Subject: Dresden Station Unit 3
 Supplementary Information to
 Cycle 9 - Reload Submittal
NRC Docket No. 50-249

Reference (a): B. Rybak letter to H. R. Denton
 dated August 25, 1983.

Figure 4.1 MSIV Closure Without Direct Scram (Power and Flows)

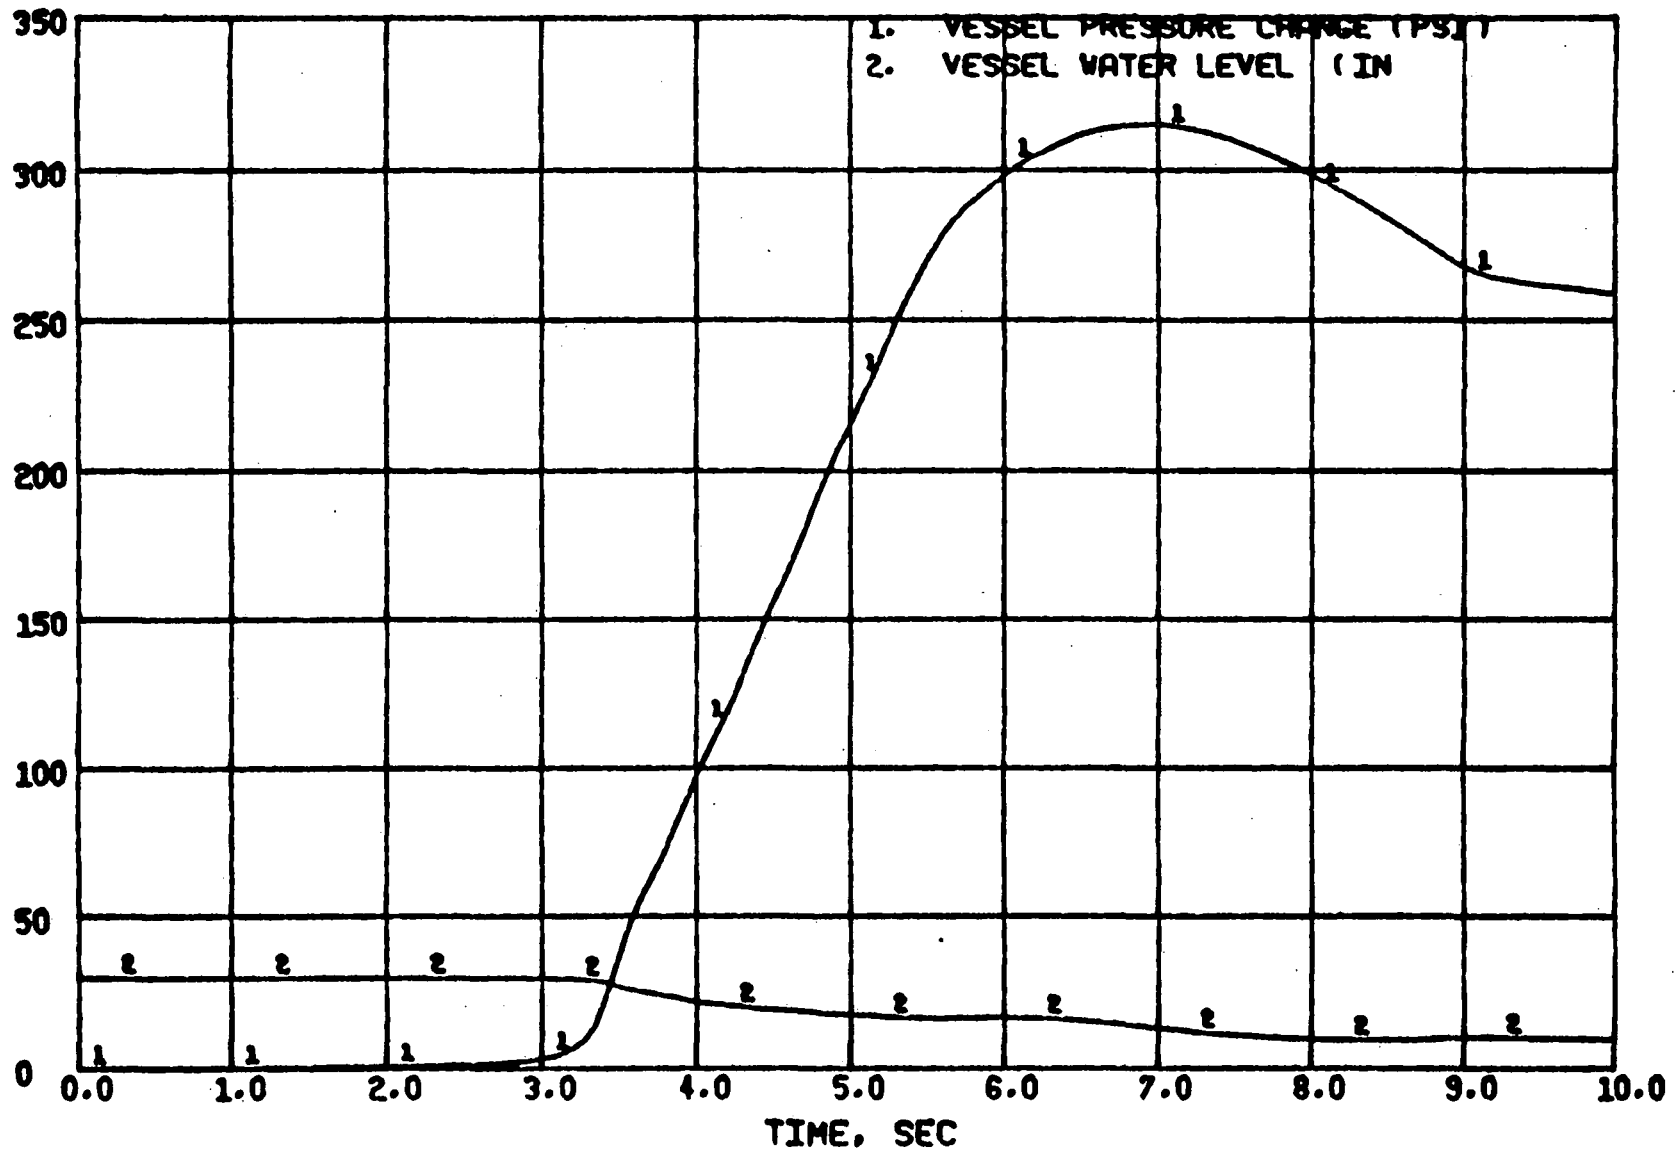
The analysis for the maximum pressurization transient as reported in XN-NF-83-58 assumes that a feedwater pump trip occurs during containment isolation. This trip function does not exist at Dresden. A reanalysis of the transient without the feedwater pump trip was performed. The new values for peak pressures are:

These values for the MSIV closure are about 3 psi lower than those shown on pages 3, 4, and 24 of the above document. Attached are figures that correspond to the figures on pages 25 and 26 of that document. Since these pressure values are slightly lower than those from the previous analysis reported in XN-NF-83-58, Commonwealth Edison has concluded that the reported results are conservative. Although CECO feels a formal amendment is not needed to XN-NF-83-58, we are submitting this revised data for your information.

Vessel Dome	1320.8 psig
Lower Plenum	1344.9 psig
Steam Lines	1320.8 psig
